**Re: Condominium Servicing  
Clark-Heinmiller Subdivision  
Palmerston, Town of Minto**

This letter has been prepared as an addendum to the Preliminary Servicing and Stormwater Management Report prepared by Meritech Engineering and dated November 2022 for the above-noted project.

PROJECT: **STACKED TOWNHOUSE CONDO SITE**  
 Ontario Street, Palmerston, Ontario  
 TITLE: **SITE PLAN**  
 SHEET No. **A1.1**

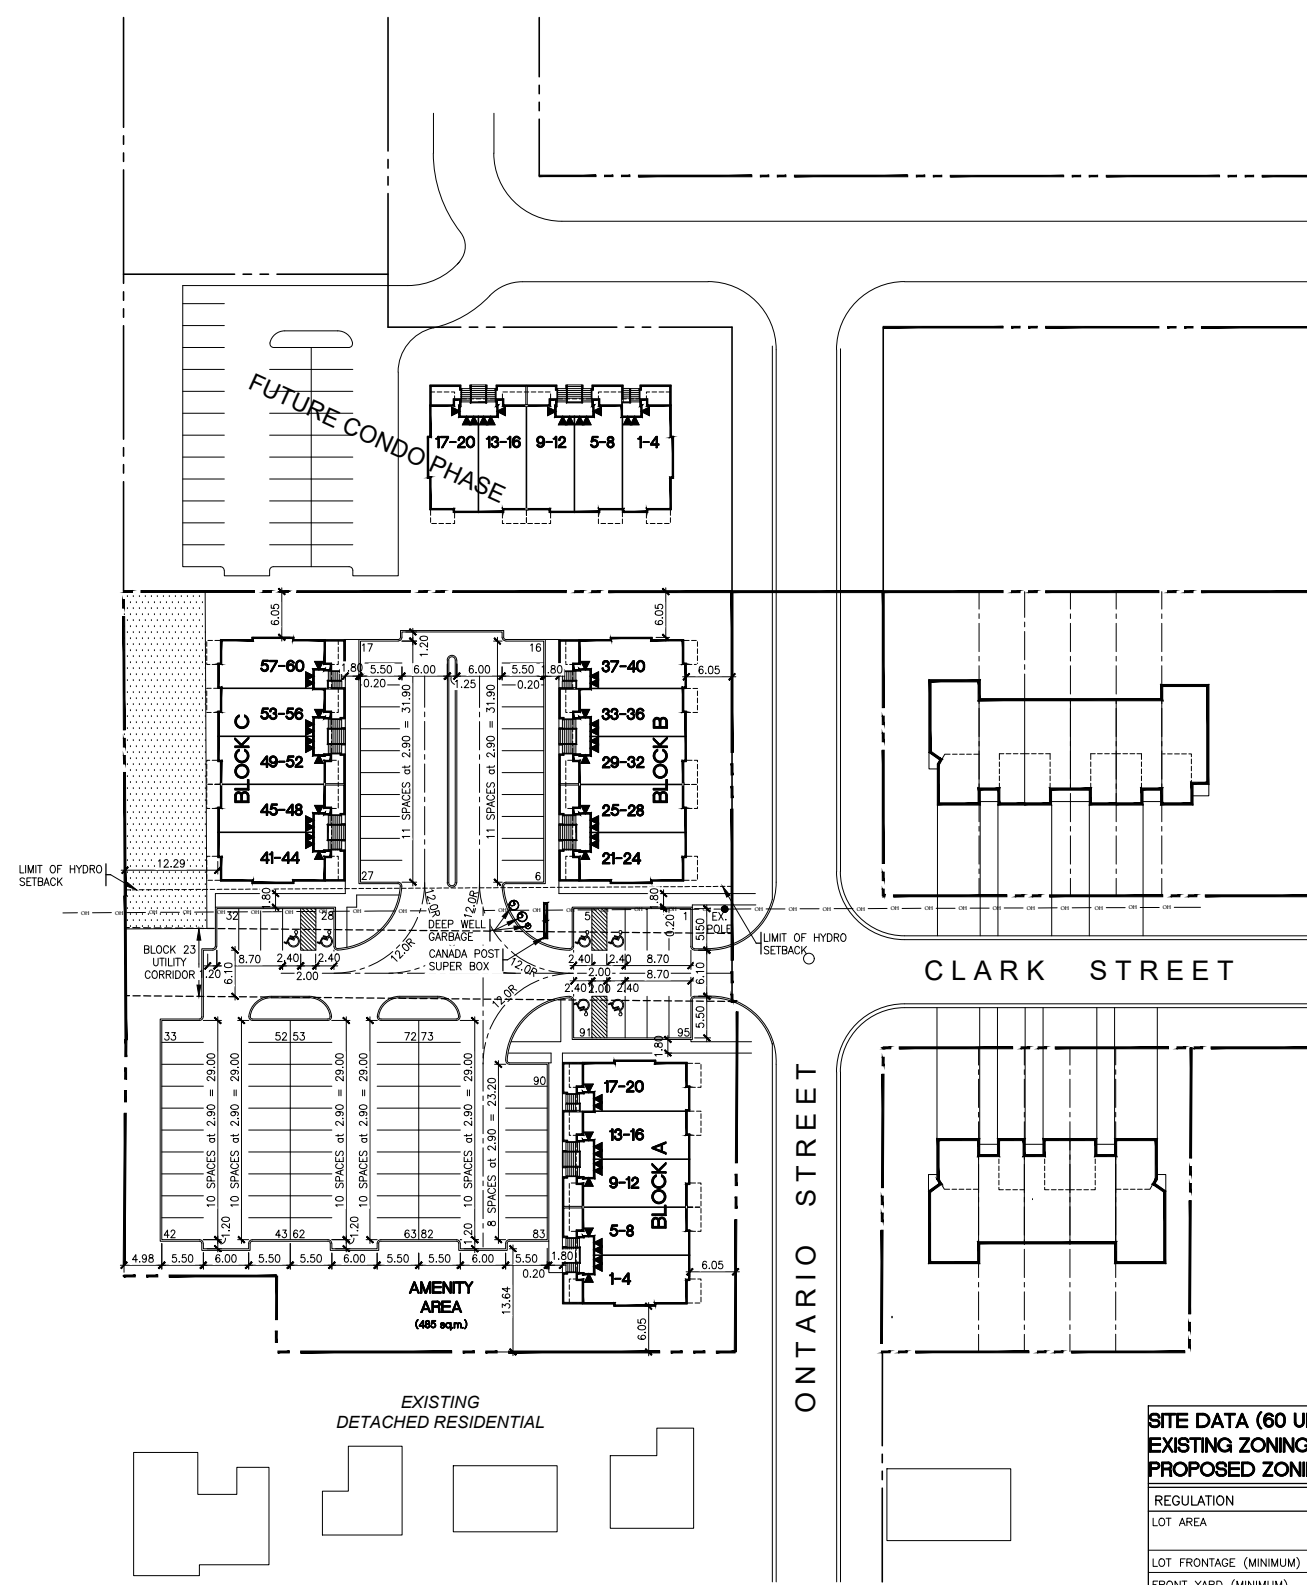
Since the preparation and submission of the report in 2022, a preliminary Site Plan for the western portion of the site has been prepared in response to the Town's desire to have Ontario Street run due north from Main Street into and through Phase 1 of the development, rather than terminating at a T-intersection into proposed Clark Street running east-west as shown on the Draft Plan previously prepared in 2022.

No negative impact on sanitary servicing due to the increased unit count/design population, as there is more than adequate capacity in the trunk sewer.

A servicing easement through the site plan block would be required instead of a municipally-owned servicing block. Therefore, this site plan results in a more efficient use of space than the previously prepared draft plan.

There is more than adequate capacity in the domestic water supply and distribution system to support the slight unit increase.

Firewall(s) may be necessary for these buildings, as they will be a storey taller than the street-facing townhouse units in the subdivision. As stated in the 2022 report, "further

Assuming that the buildings would not be sprinklered, the OBC’s requirement is only that all principal entrances are within 90m of a hydrant. Using these criteria, there would not be a need for a private fire hydrant within the site; a single public hydrant at the intersection of Ontario Street and Clark Street would provide coverage. As a result, the water service size to the private site would not need to be overly large.

There are options available to accommodate the increased imperviousness resulting from proceeding with the Site Plan option.

The first option is that the additional impervious, which results in additional storm runoff, be handled in the end-of-pipe SWM facility. Tables 11 and 13 of the 2022 report shows that the pond is able to attenuate the extra runoff with no negative effect.

The second option is that a level of quantity control be required, to minimize the impact on the pond sizing and not over-estimate the pond size required. This typically is accomplished by requiring the design for the block to reduce the peak outflow to a specified runoff coefficient. For example, the 100-year runoff rate could be limited to a runoff coefficient of 0.7. This would result in the grading and servicing design for the Site Plan to include some underground or aboveground storage. Likely, the approach would be that there would be some surface ponding on the parking lot in large storm events.

Due to the relatively small impact that the increased imperviousness results in, the first option is preferred. This option has the fewest grading and servicing constraints for the Site Plan block.

So that drainage from all impervious areas is captured and conveyed to the SWM facility, it appears that slopes and/or retaining walls at the southwest corner of the block would be required.

Although the creation of a Site Plan block would result in a number of minor design edits there are not anticipated to be any negative impacts on the overall design.
